Social Housing Renewal Standing Advisory Committee

Walker Street, Northcote

Report No 5

Report No 5 – Walker Street, Northcote

Concept Plan

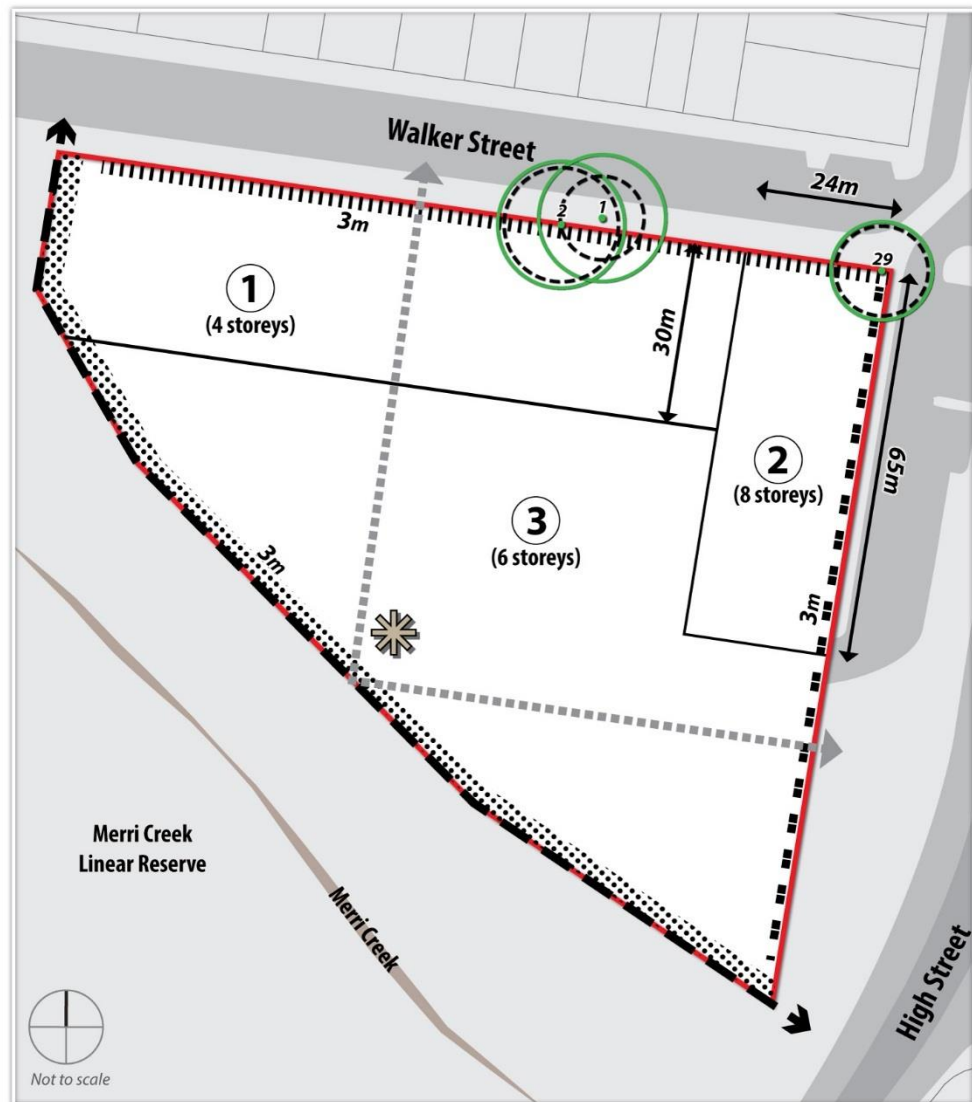
Mr Sheppard's evidence was that the Concept Plan should be amended to realign the boundary of Area 1, delete the internal road connection, relocate the proposed park to the southern boundary, and that the connection from Walker Street follow a straight line to the creek reserve. Mr Sheppard supported the assessment of reasonable levels of sunlight to open-space, both within and outside the Estate to be on 21 June. He supported introduction in the DPO of concealed or basement car parking.

In the Committee's view, however, maintaining the existing 1960s roadway reserve in the centre of the site is of little efficacy if appropriate access to the carparks can be provided in another way. The inclusion of an internal roadway presents an unnecessary constraint on the redesign of the housing and on the ability to provide appropriate setbacks and open space, to enhance both resident amenity and the relationship with Merri Creek.

The considerable fall across this part of the site provides the opportunity to access a cross-site underground/podia parking area, accessed at either end from the existing site entrances if desired. The car parking area could extend across the site and under the internal street area and provide direct access to all buildings. The area occupied by the roadway could then become an open space spine for residents and form a pedestrian linkage to the new park while providing increased options for the design of the buildings facing it. The new one to two level parking could be sleeved on all sides, while leaving the area for the proposed park unencumbered by a basement beneath.

The Development Plan must be generally in accordance with the Concept Plan forming part of this schedule to the satisfaction of the Responsible Authority.

- A new centrally located public open space area, generally located as shown on the Concept Plan. This area may form part of the communal open space required under Clause 55.07-2 or Clause 58.03-2.
